ADDENDUM 05
DELAWARE TECHNICAL & COMMUNITY COLLEGE
ALLIED HEALTH – C-WING ADDITION & RENOVATIONS

January 31, 2013

Project Number: BSA+A # 11.103

Subject: **ADDENDUM 5**

ADDENDUM #5 ENLARGED PLAN - LIGHT BOX

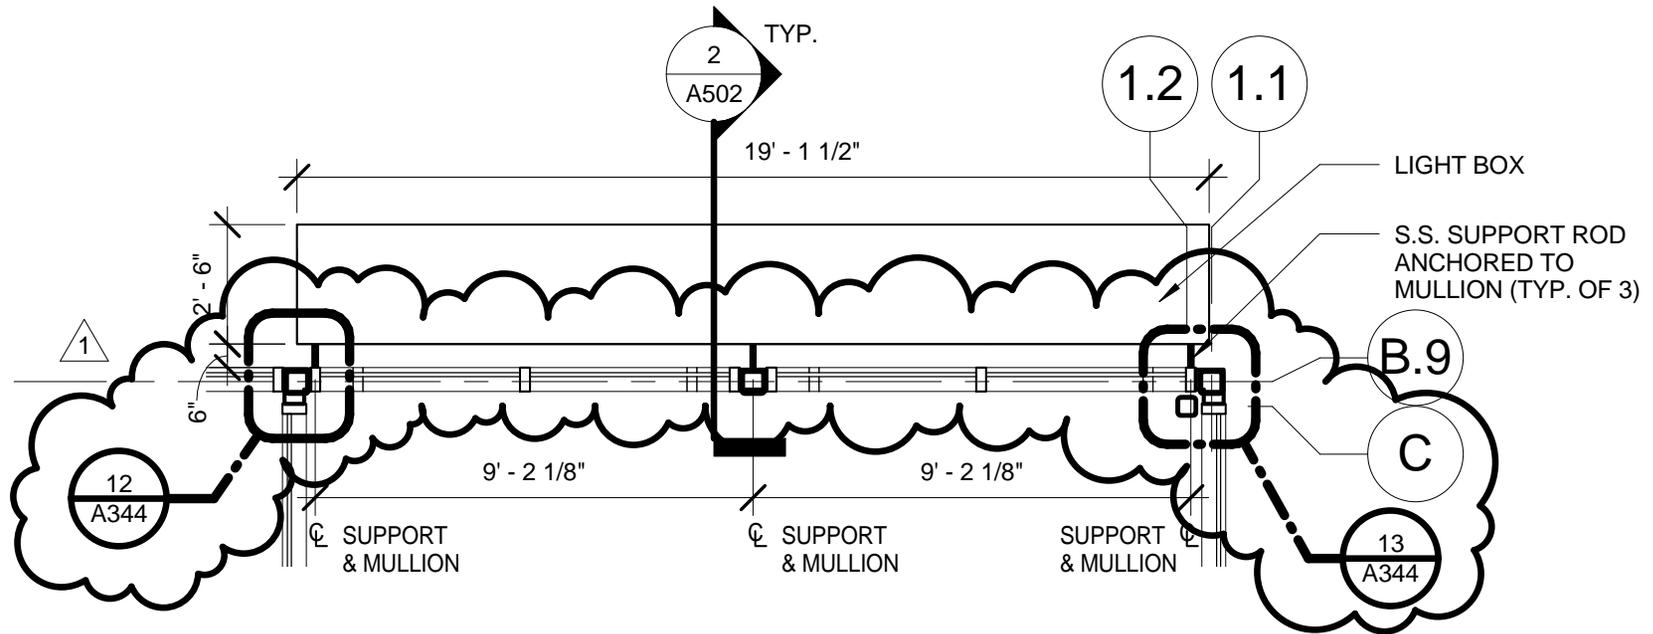
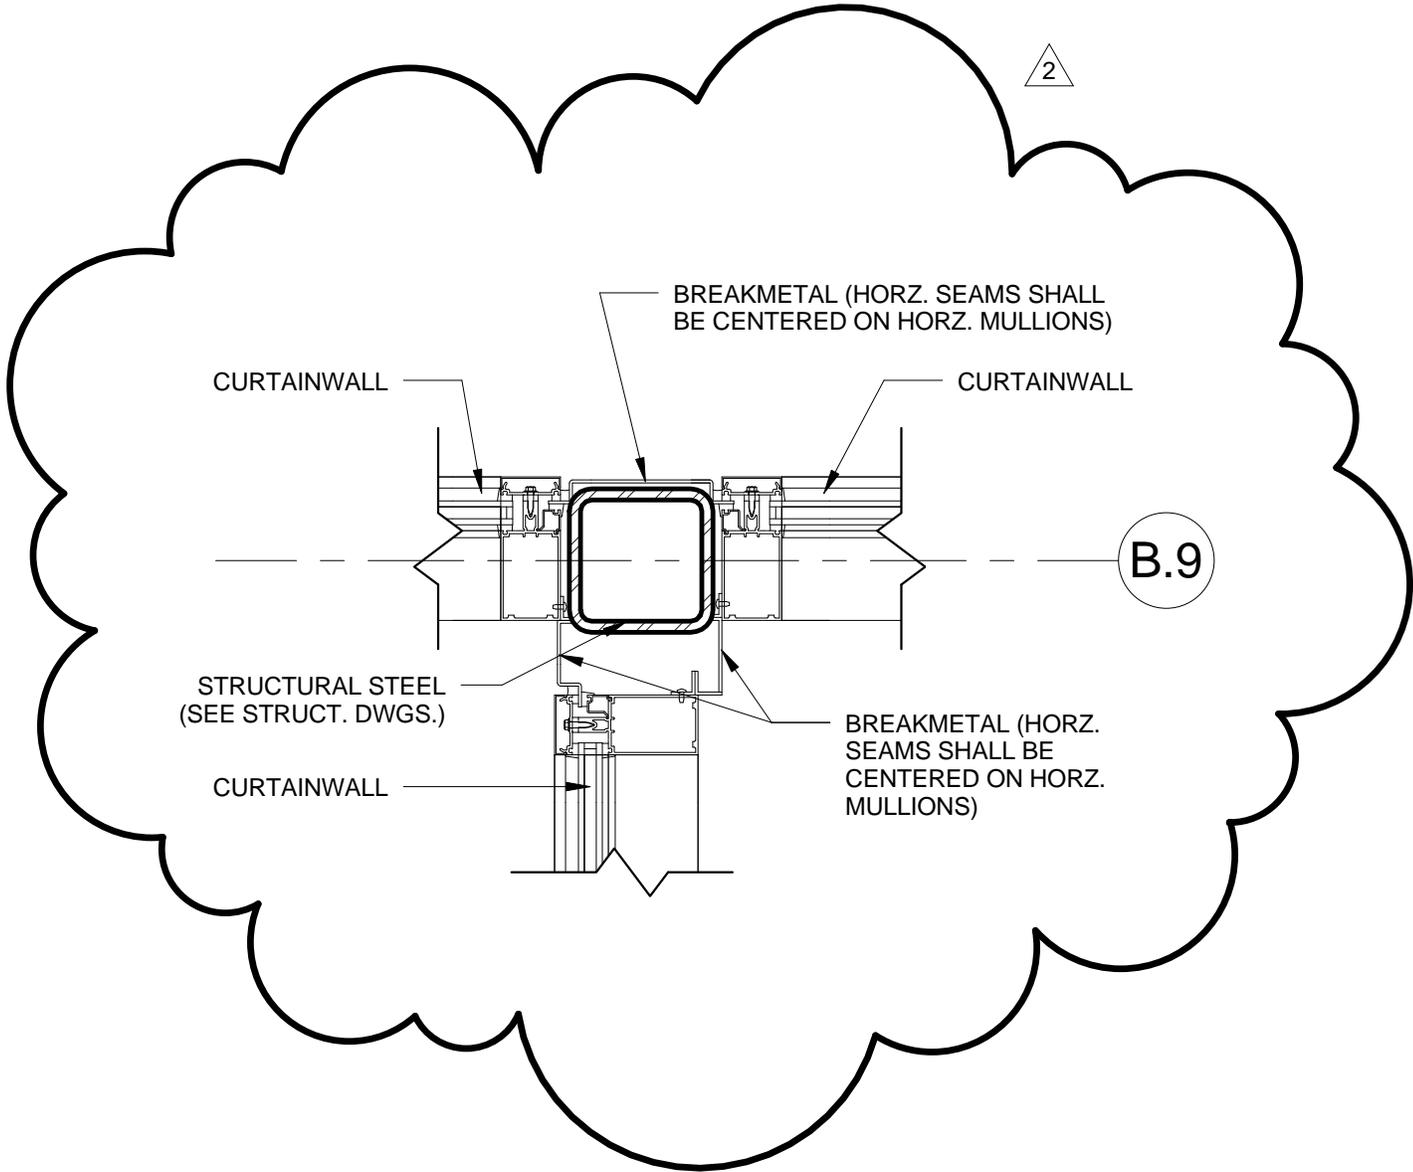
D-14		Drawing A412 – Curtainwall Types: a.) Add Film Types to legend per Architect’s Supplemental Sketch ASK-029 .
D-15		Drawing A501 – Misc. Details: a.) Revise detail 6/A501 per Architect’s Supplemental Sketch ASK-026 .
D-16		Drawing A502 – Misc. Details: a.) Add structural steel columns to details 12/A344 & 13/A344 per Architect’s Supplemental Sketch ASK-023 .

Detail A
SSK-1

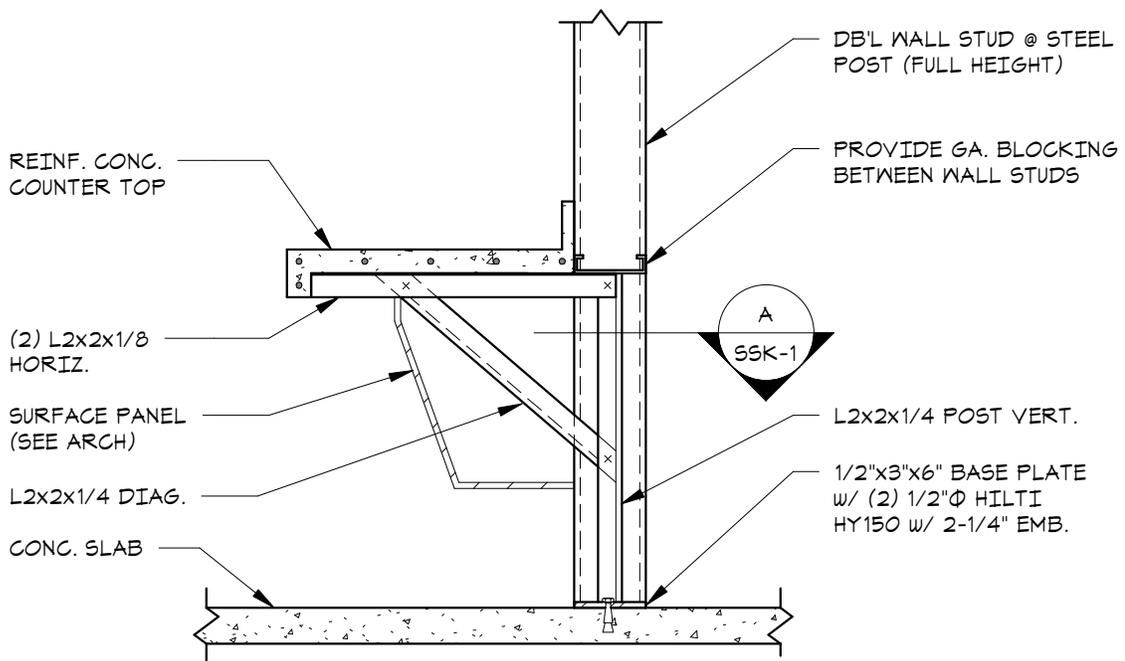
Item No.	Description:
D-1	Drawing S-503: a) Add supplemental framing support for concrete counter tops. Refer to Structural’s Supplemental Sketch SSK-1 .
D-2	Drawing S-102 – Second Floor Framing Plan: a) Revised designation in plan notes for full moment connection and wind moment connection locations. Refer to Structural’s Supplemental Sketch SSK-2 .
D-3	Drawing S-103 – Roof Framing Plan: a) Revised designation in plan notes for full moment connection and wind moment connection locations. Refer to Structural’s Supplemental Sketch SSK-3 .
D-4	Drawing S-101 – Foundation Plan: a) Additional steel columns added to support exterior light box framing. Refer to Structural’s Supplemental Sketch SSK-4 .
D-5	Drawing S-102 – Second Floor Framing Plan: a) Additional steel columns added to support exterior light box framing. Light Box is attached to the vertical steel posts. Refer to Structural’s Supplemental Sketch SSK-5 .
